Our Case Number: ABP-316119-23

Re: DART+ South West Electrified Heavy Railway Order - Hazelhatch & Celbridge Station to Heuston Station,
and Hesuton Station to Glasnevin
County Dublin and County Kildare

DART+ South West submission

Figure 1: Elevation change across Heuston West Station

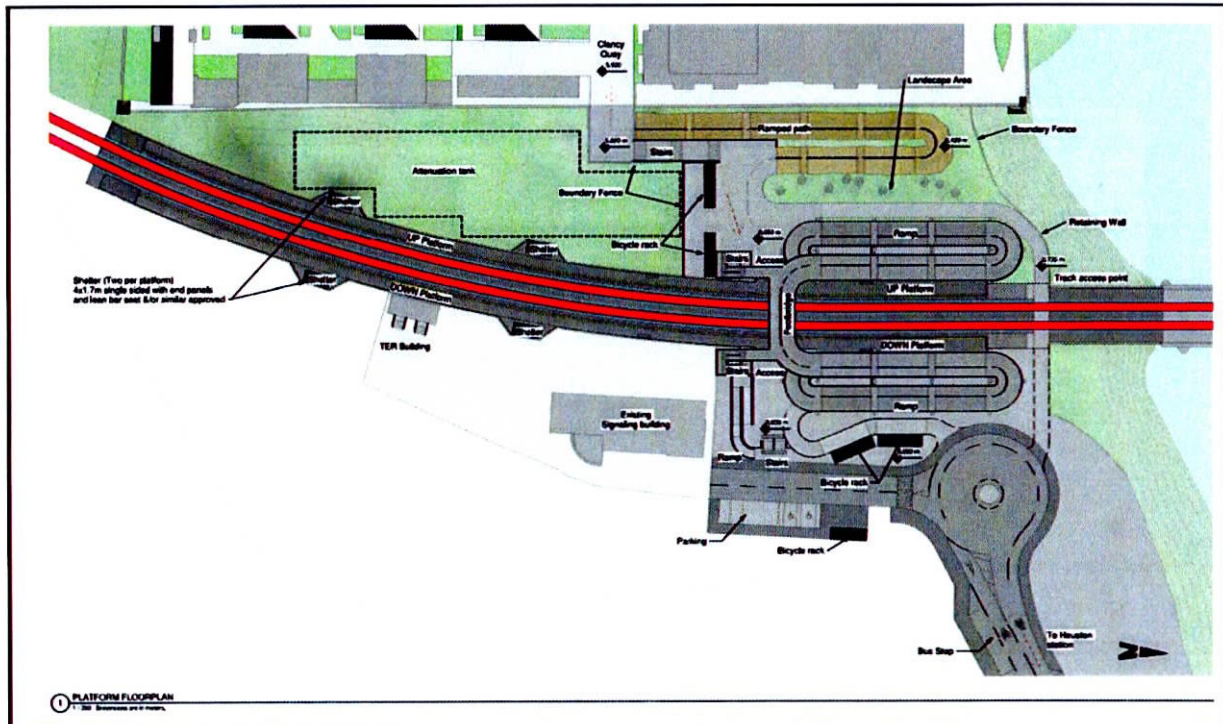
It is noted that the Heuston Station design includes a ~4m ramped incline from the Clancy Quay side which would be followed by another ~6m ramped incline and decline to access the DOWN Platform. We ask that the project team liaise with accessibility groups on the design of all stations to get a greater understanding of the design impact.

The ramp-only design included in these plans has been most recently shown to be discriminatory and impractical at the new Pelletstown station built in 2021. One wheelchair user told us that it takes her five minutes to move from one side of Pelletstown station to the other when pushed. It's completely unacceptable that Irish Rail would propose to continue discriminating against people with reduced mobility in a brand new station. It is vital that lifts are included in the designs for Heuston West, Cabra, and Kylesmore stations, and in any other future stations.

Figure 2: Heuston Masterplan

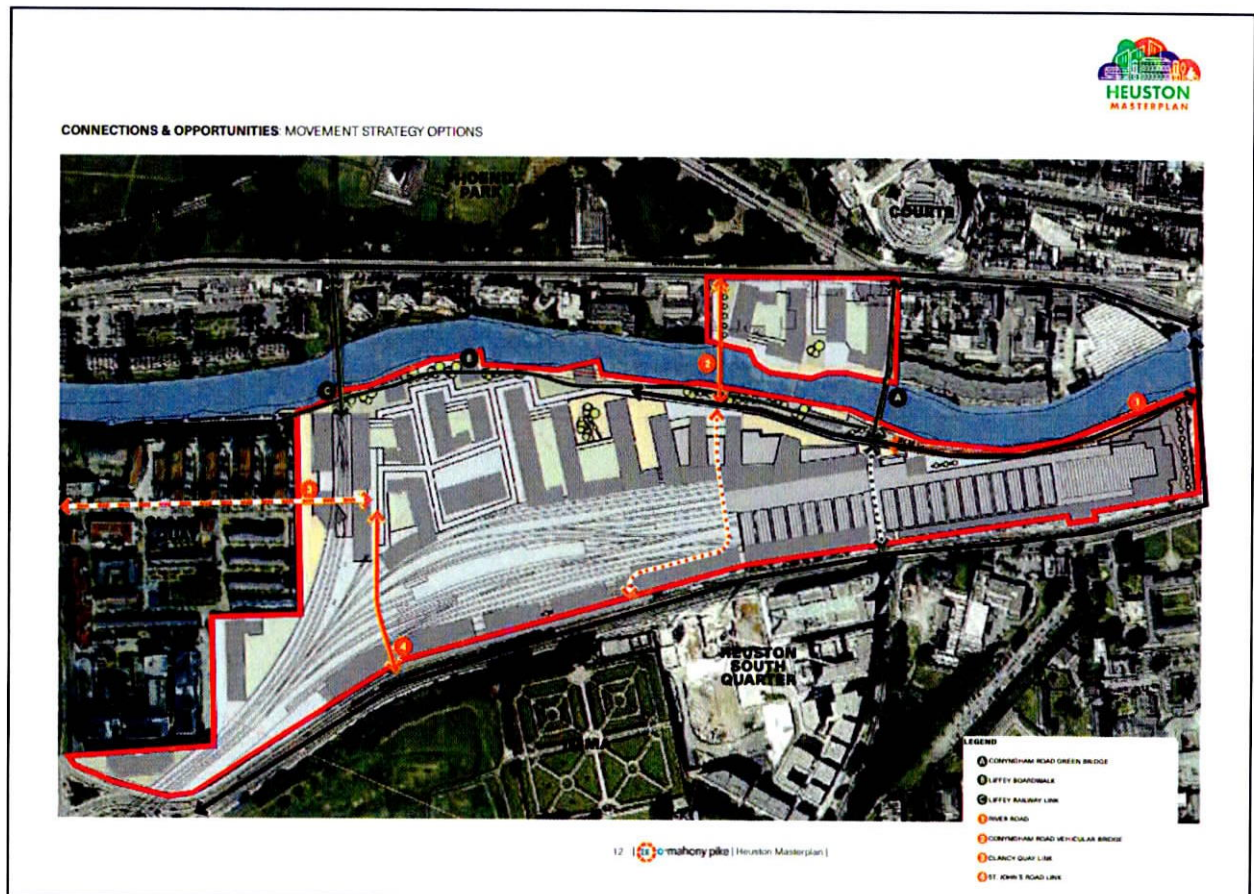
It is also noted that there is no pedestrian access from Conyngham Rd to Heuston West station. This is a missed opportunity to link the Residential and commercial Developments along Conyngham Road with high frequency public transport. It is noted that the CIE masterplan for Heuston includes the Liffey Railway Bridge Link as a potential pedestrian/cycle link. Introducing this as part of Dart South West would expand the catchment population with access to the new Heuston West station and would not preclude other options being pursued while offering alternative access during future Heuston Masterplan development – referenced on the CIE website under <https://www.cie.ie/CIECorporate/media/reports/Heuston-Masterplan-final.pdf>

Figure 5: SCR/Chapelizod Updated Road Layout

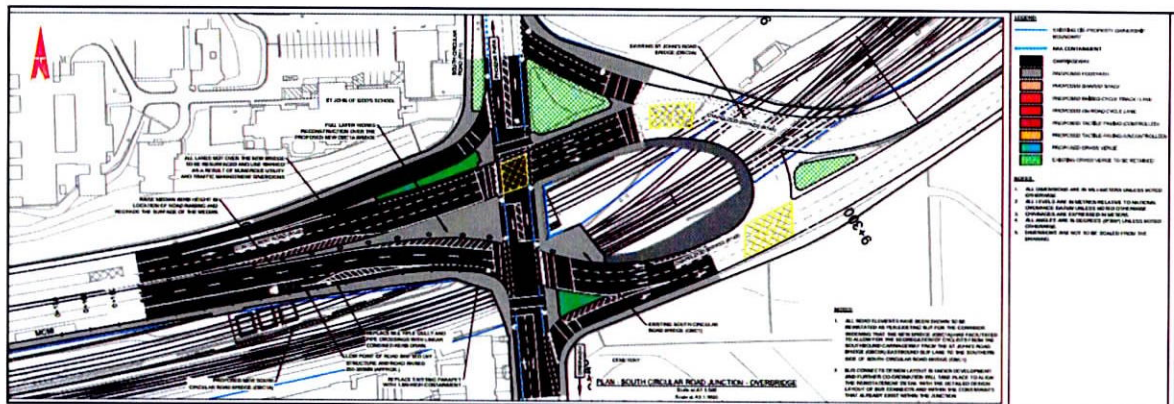
The reinstatement of the Chapelizod and South Circular Road Bypass to the same road design is a missed opportunity to enhance active travel infrastructure linking Kilmainham and Islandbridge and to improve active travel connectivity to Heuston Station. There is currently no cycle provision on the Chapelizod Bypass road heading west through the roundabout or turning right onto the South Circular Road.

We note the lack of consideration given to the redesign of this junction included in the BusConnects application currently before An Bord Pleanála and seek clarification on which plan will be implemented.

Figure 6: Current Khyber Pass Design

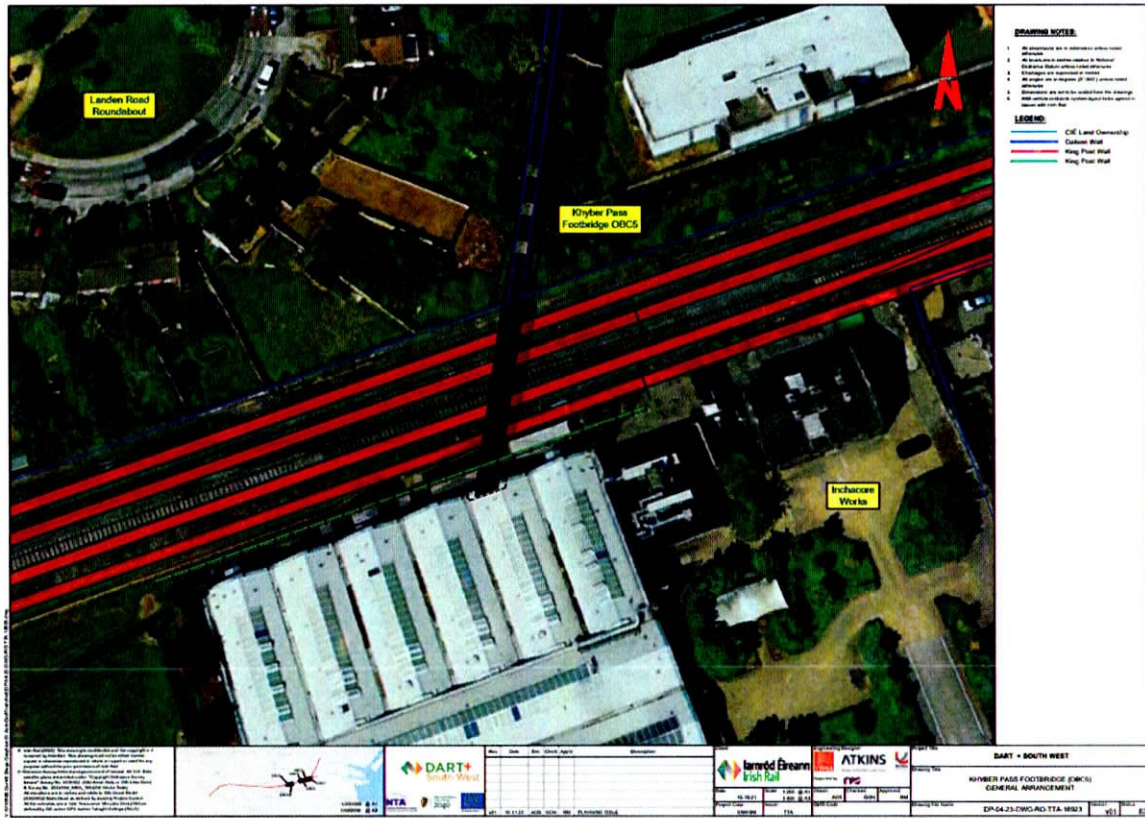
The New Pedestrian Bridge being built at Inchicore Works should be designed to allow public access in order to improve permeability for the area.

Figure 7: Current Bike Shelters

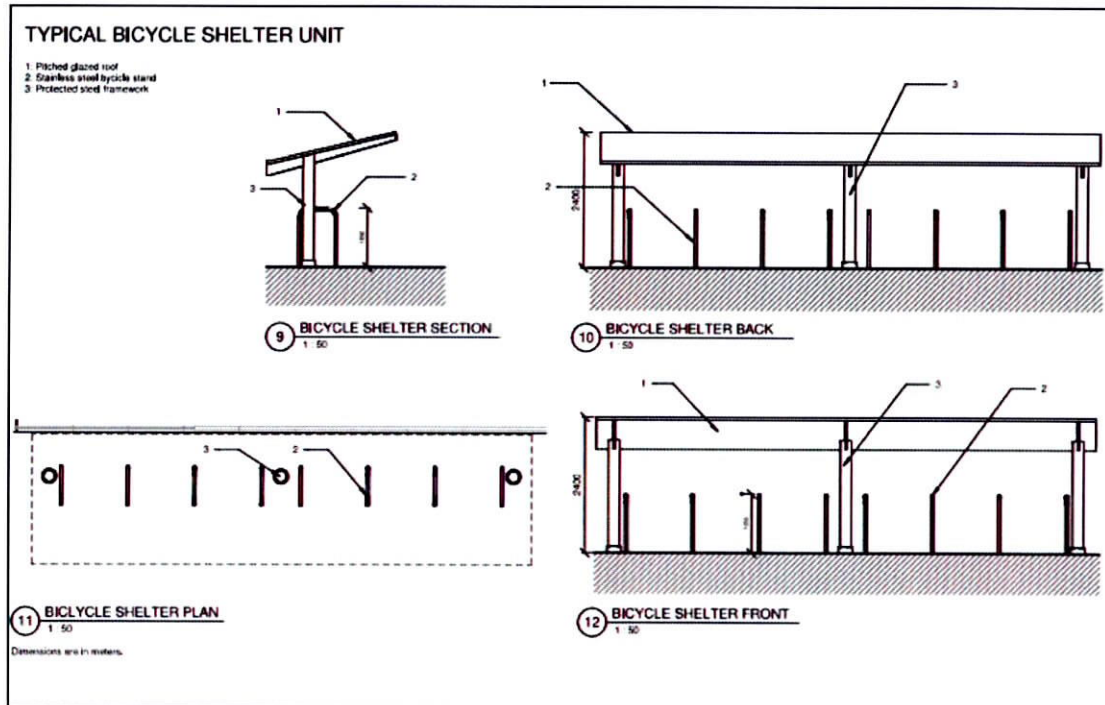
The current provision of Bike shelters at the Heuston West Station is welcomed but as a new station which should cater for more active travel there should be a provision for Bike lockers included in the plan. It is noted that Heuston has 69 bike lockers in place but Heuston West needs its own provision given the distance from the main Heuston station. The provision of bike lockers should be included in the station design. It is noted that the CIE Heuston Masterplan includes provision for extensive bike parking with 5,000 bike parking spaces but the current station design for Heuston west only offers standard bike shelters. We think that the Heuston West station design should be built with a provision for secure bicycle parking as has recently been completed at the Amsterdam Central station. This offers a secure bike parking location for those taking longer trips and includes double racks to enhance bike parking capacity and a variety of racks/spaces to facilitate mobility options including cargo bikes.

Figure 9: Houston West Station

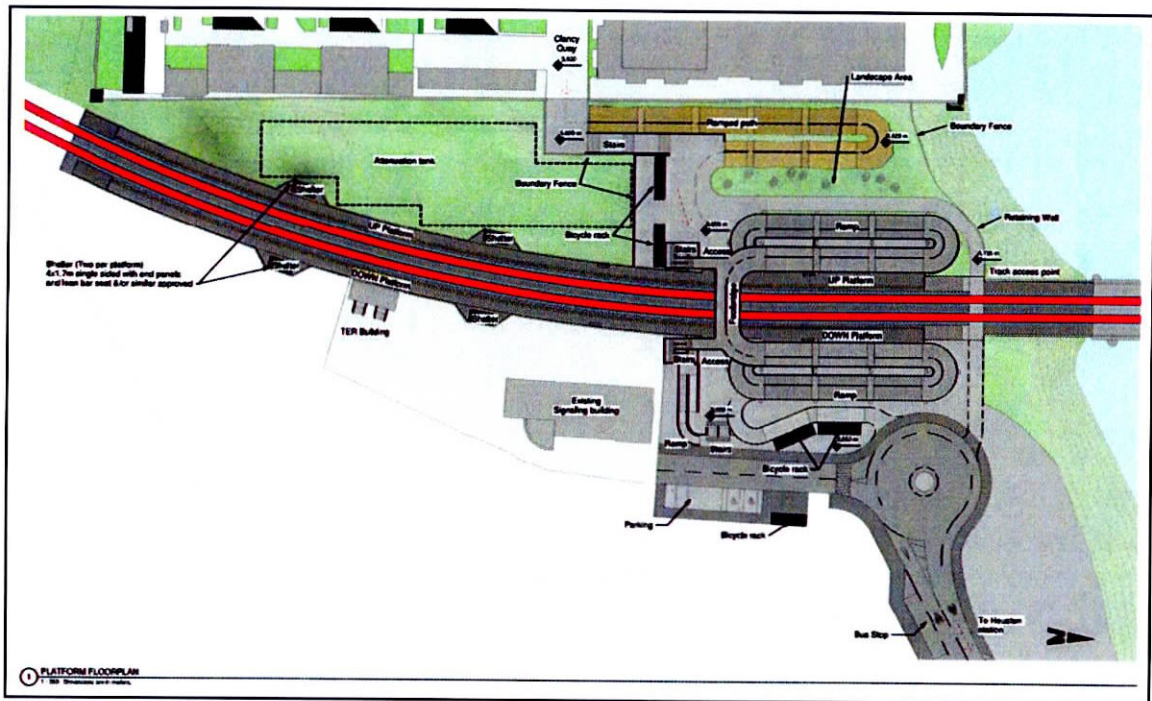
The proposed access to Heuston West station through to Heuston Station Road features unsafe roundabouts, cyclists mixing with bus parking bays and an unnecessarily wide road. This design simply does not comply with the Design Manual for Urban Roads and Streets or the National Cycle Manual. Irish Rail must be made to redesign it.

This project has provided for an abundance of car parking at Heuston West. This is a crucial public transport link in the city centre and the number of car parking spaces should be limited to service vehicles and blue badge holders. This will free up space to construct appropriate sheltered and secure cycle parking with the necessary bike maintenance and charging facilities. Encouraging people to drive to this location is antithetical to the project's stated goals of reducing transport emissions as part of the State's Climate Action Plan 2023.

Figure 10: Kylemore Road

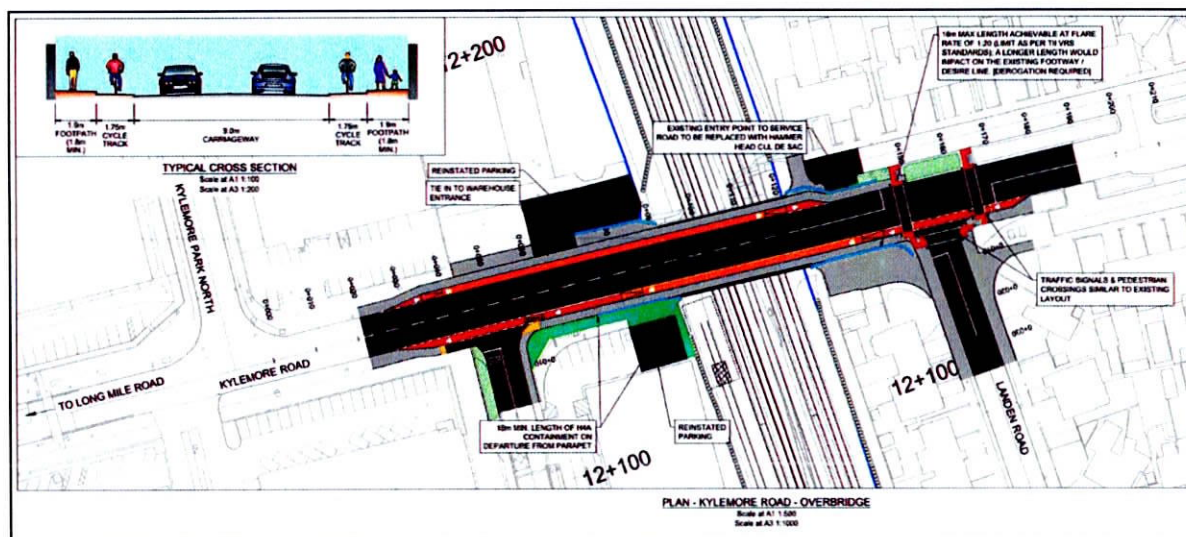
The road design proposed for Kylemore Road and Memorial Road fails to meet the minimum requirements set out in the Design Manual for Urban Roads and Streets (DMURS). The current design of the Kylemore Road dedicates 9.0m to carriageway and just 1.0m to footpath and 1.75m to cycletrack. The carriageway should be a maximum of 6.0m wide at this location with significant road space reallocation for walking and cycling. Raised crossings at unsignalised side roads should also be provided.

Dublin Commuter Coalition advocates that the road design for this section follow the recently completed "Rapid Build Scheme - Brookeville Ave to Ivans Cross" by the Active Travel team at Limerick City and County Council. This project utilised an existing 9m wide carriageway to provide two way general traffic and a bi-directional cycle path (Figures 11, 12). This approach calms traffic, improves local connectivity, and creates a safe cycling environment for all ages and abilities.

Figure 11: Memorial Road

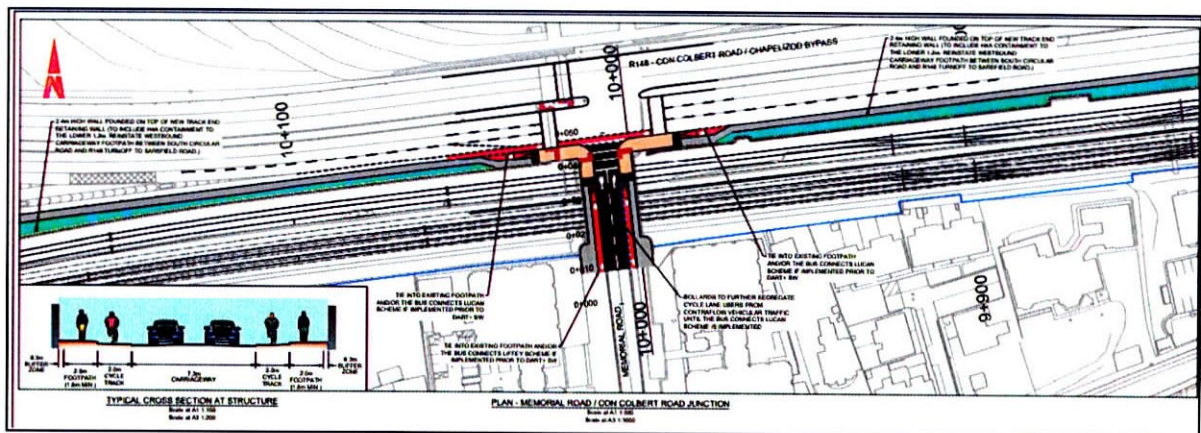
The current design for Memorial Road is also substandard in terms of width, segregation, and it does not include any provision for cyclists to cross the Chapelizod bypass - except to mix with vehicular traffic or pedestrians. This junction update should include clear segregation for cyclists making the right turn. The signalisation should also include a cycle priority signal to enable safe crossing ahead of vehicular traffic. Again, there is no acknowledgement of the redesign of this road and junction currently proposed as part of the BusConnects program.
